## DOCUMENT CHANGE REQUEST

DCR number            324            Changes required for: General  
Date: 2007/02/21            Date sent: 2007/02/21  
Status: IMPLEMENTED

Title:            Transistors High Power NPN, based on type BUX77

Number:            5203/016            Issue:            1

Maximum Safe Operating Area Graph

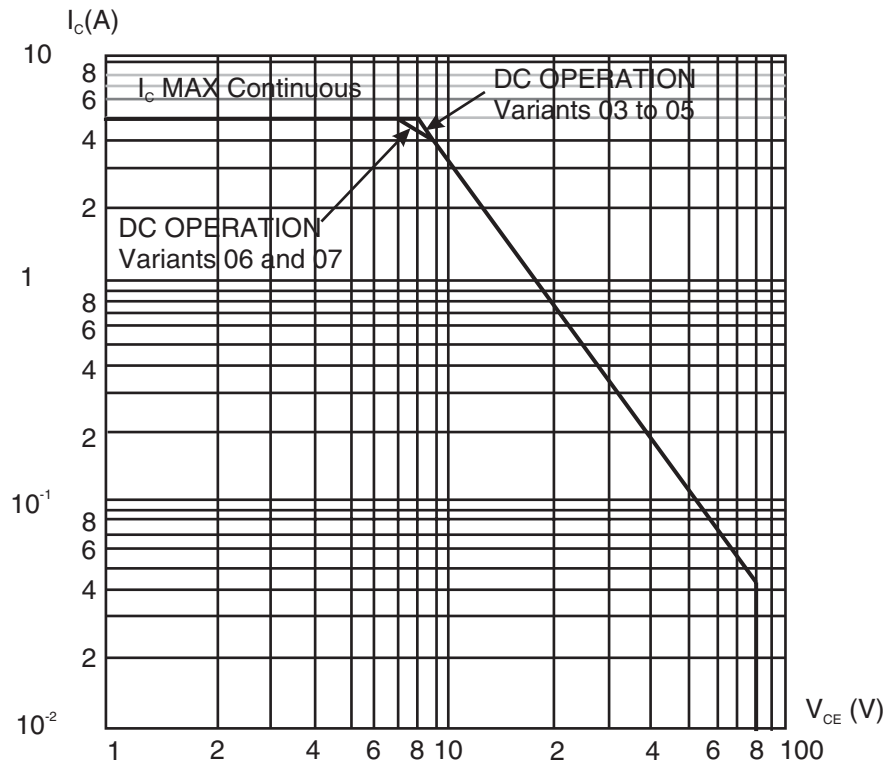
1. Rewording and restructure of various sections and paragraphs of the specification plus other editorial changes based on the layout and editorial content of other Detail Specifications already converted to ESCC format (e.g. changes described in DCR No. 203).
2. Deletion of any redundant paragraphs and information, e.g.: Mechanical Requirements.
3. Para. 1.7 High Temperature Test Precautions requirements moved to be a note in the Maximum Ratings table.
4. Deletion of obsolete lead finishes D2, D3 and D4 / Variants 01 and 02 from the available range (not supported by STMicroelectronics).
5. Figure 1(a) Parameter Derating Information moved to be a note in the Maximum Ratings table.
6. Figure 1(b) Forward Bias Safe Operating Area (Continuous DC) amended and moved to be a note in the Maximum

1.7 PHYSICAL DIMENSIONS AND TERMINAL IDENTIFICATION

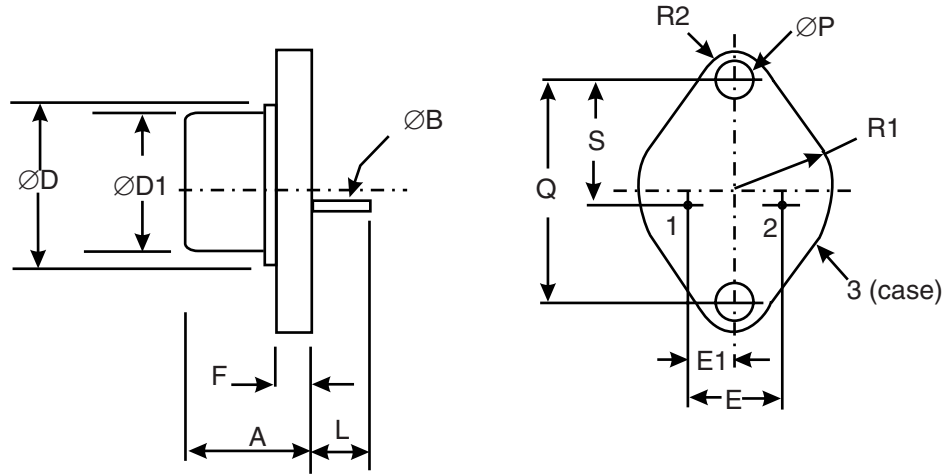
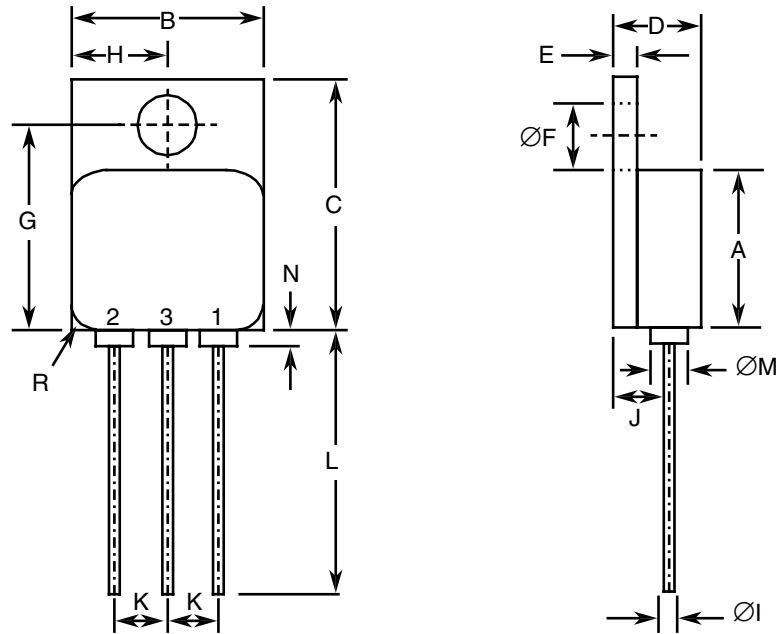
8. Figure 2 re-named â..Physical Dimensions and Terminal Identificationâ.; Figure 2(a) amended to reflect the TO-66 package currently supplied; Figure 2(b) amended to reflect the TO-257 package currently supplied. Consolidated notes added.

VOLTAGE WAVEFORMS

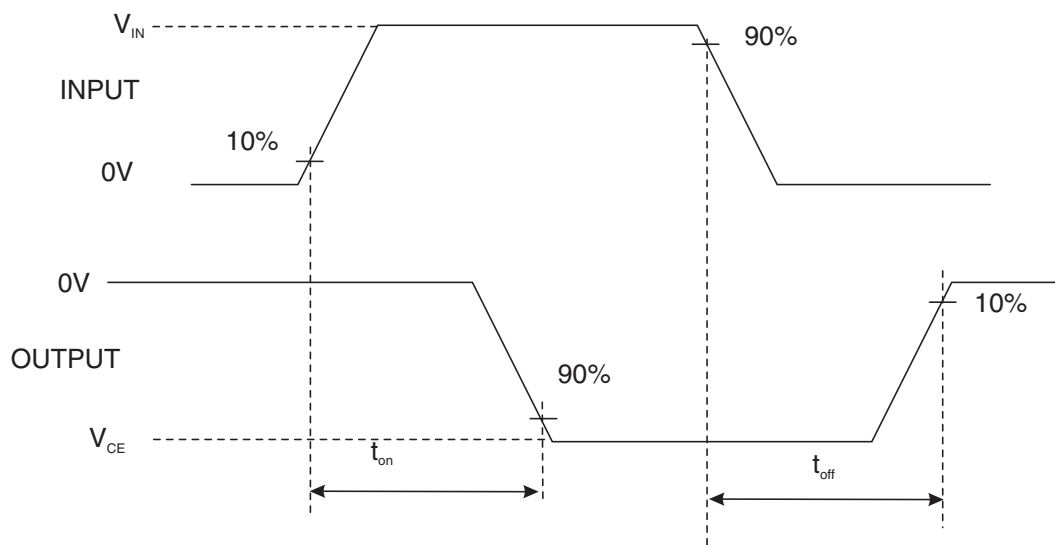
17. Table 2 and Figure 4: The Switching Times characteristics have been amended to reflect the new format.

Maximum Safe Operating Area Graph

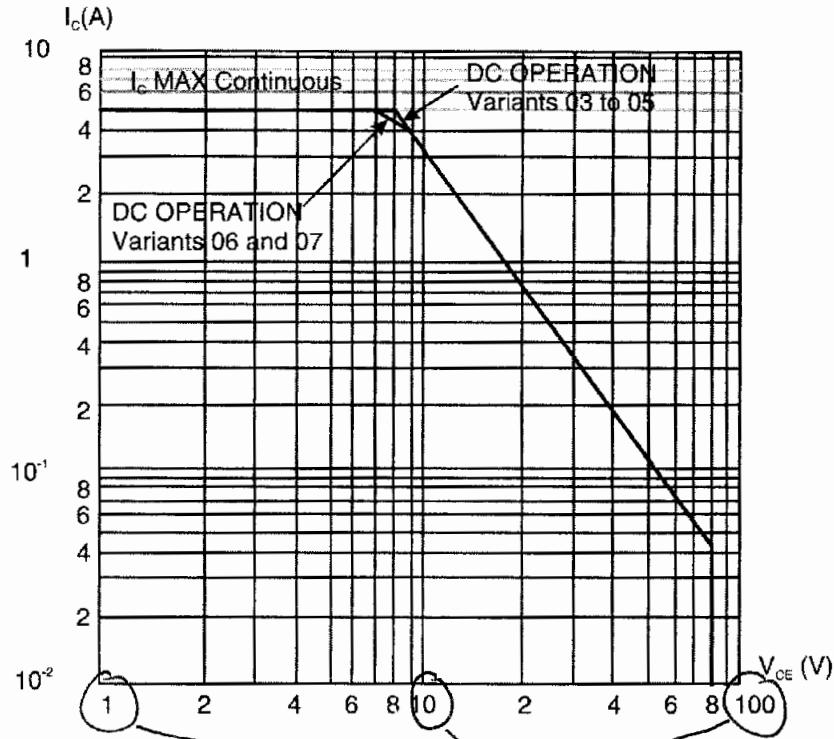
*make lower &/or larger than the other numbers (eg: 6 8 100)*
